# UNITED STATES PATENT AND TRADEMARK OFFICE

APPLICATION NO.	FILING DATE	FIRST NAMED INVENTOR	ATTORNEY DOCKET NO.	CONFIRMATION NO.
10/510,838	05/18/2005	Emil Edwin	0001885USU/3053	3864
27623	7590	11/02/2006	EXAMINER	
OHLANDT, GREELEY, RUGGIERO & PERLE, LLP ONE LANDMARK SQUARE, 10TH FLOOR STAMFORD, CT 06901			PRICE, CARL D	
			ART UNIT	PAPER NUMBER
			3749

## Office Action Summary

A method of viewing the flame produced by a burner in a pyrolysis section of a petroleum cracker furnace, wherein the fuel burnt by the burner is natural gas, comprising viewing the flame through an interference filter adapted to pass light of the wavelength of sodium only.

Fig. 1

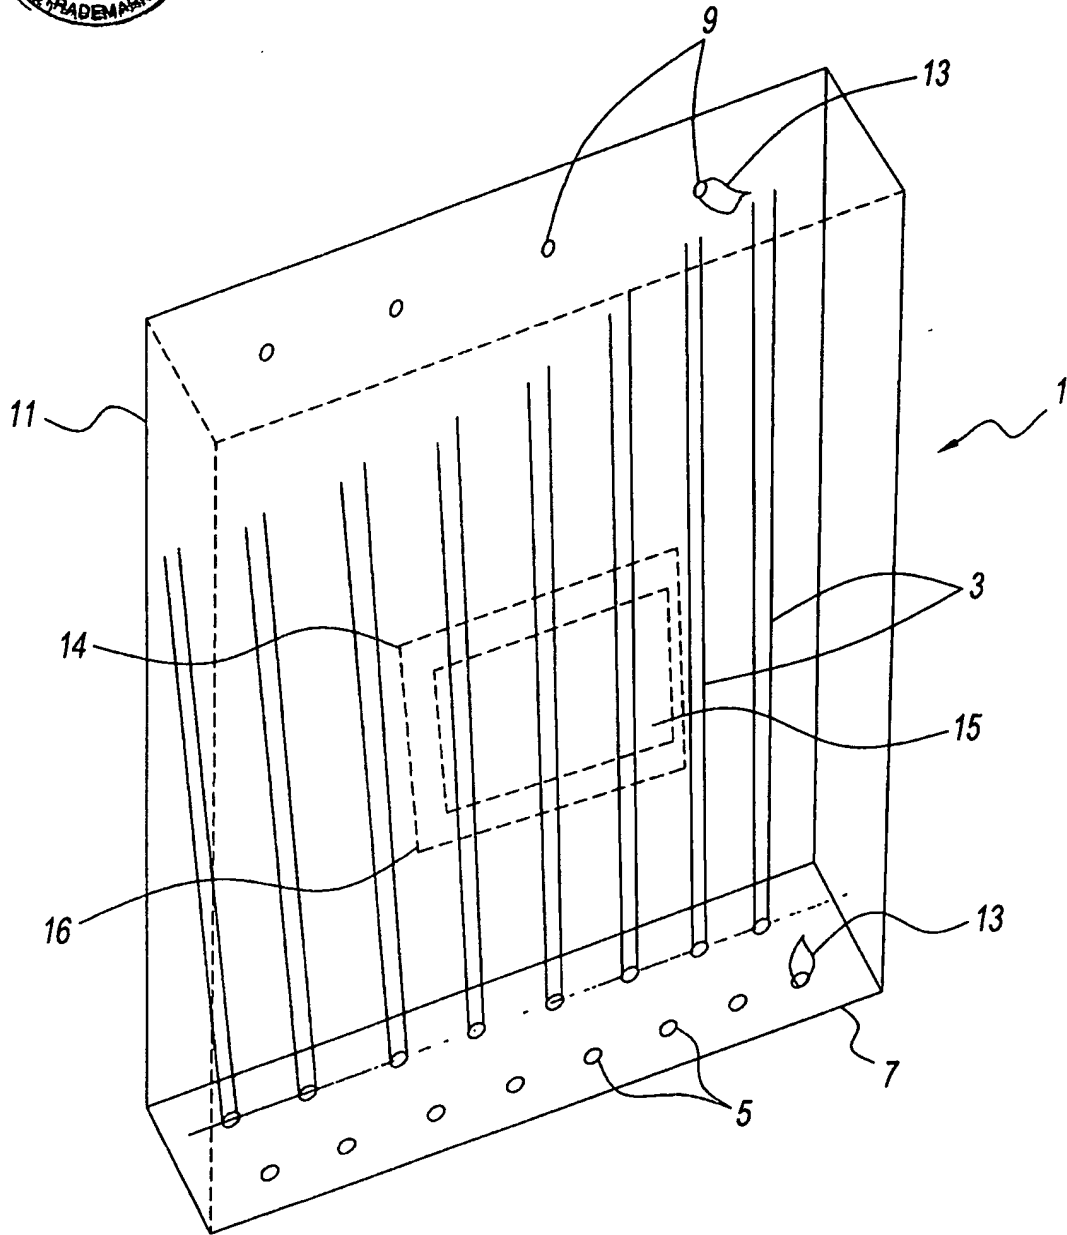
The Replacement drawing Figure 1 and new Figure 3 have not been approved as they fail to comply with 37 CFR 1.84(p)(5) because they include the following reference character(s) not mentioned in the description: Reference characters 14 and 16 (Figure 1). Reference character 20 (Figure 3).

NOT  
Approved  
of  
Reference 10/24/06  
NUMERALS 14, 16  
missing in  
spec.

Fig. 2

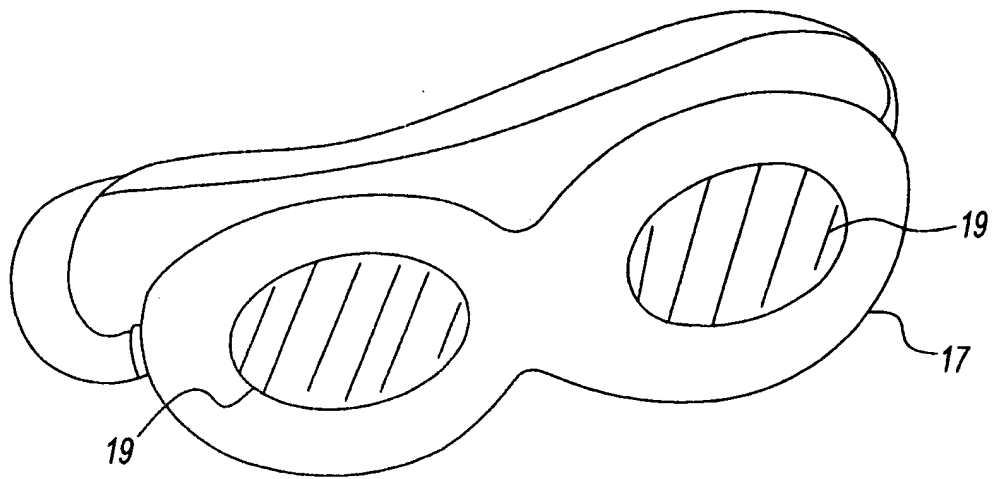
The Replacement drawing Figure 2 has been approved.

removed  
of 12/28/06

**Fig. 3**

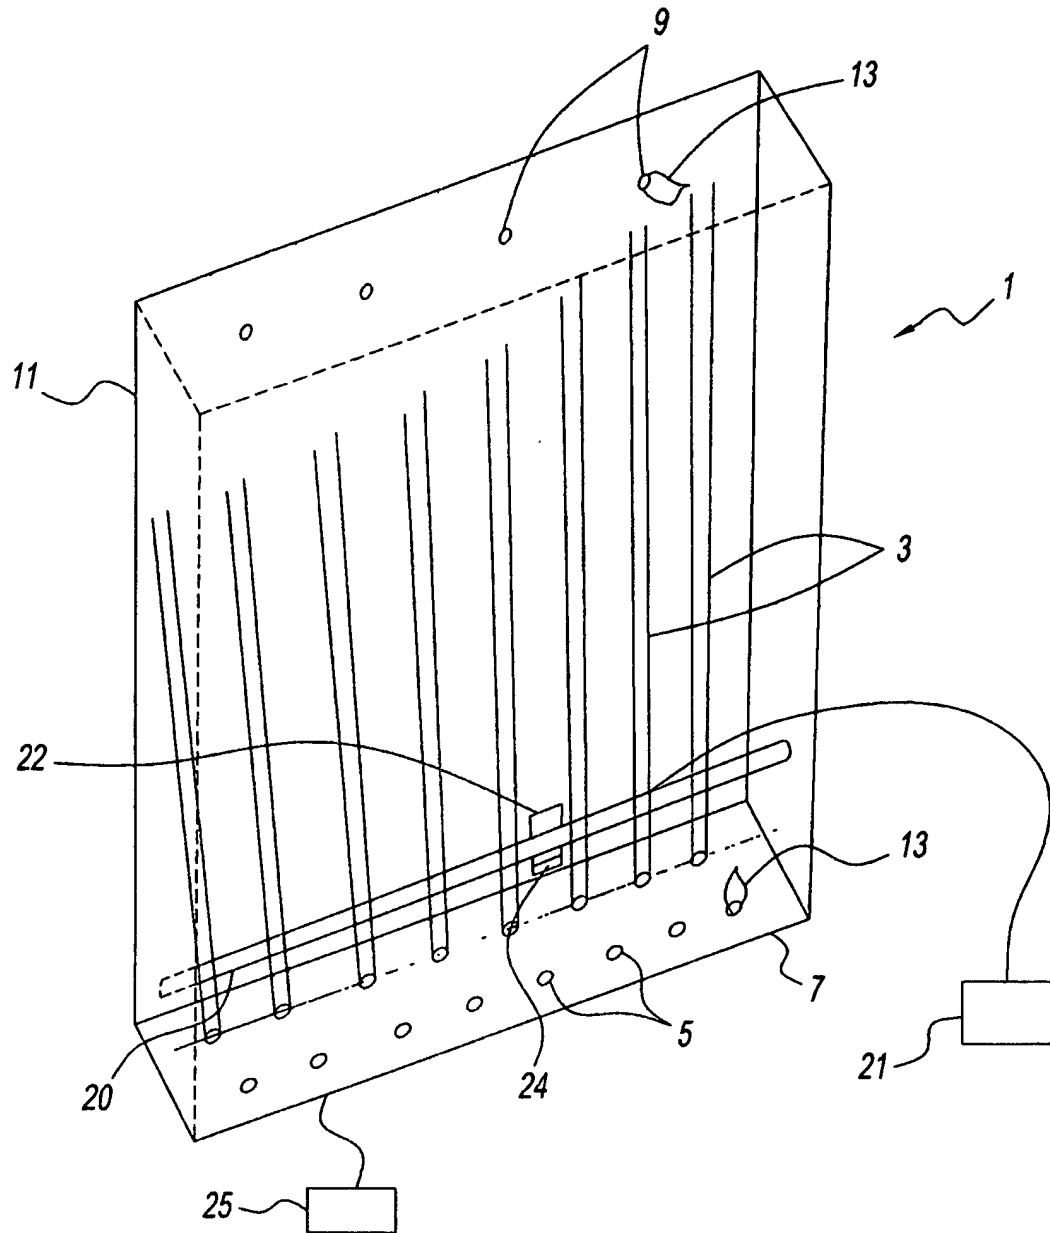
Newly added drawing Figure 3 has not been approved as it introduces new matter. See below.

The particular arrangement of elements illustrated in Figure 3 including, and not limited to, the use of a bar oriented at the particular orientation and location shown, the manner in which the relay connects to the bar, and the particular location of the filter (24).

NOT APPROVED  
10/24/02  
NEW MATTER
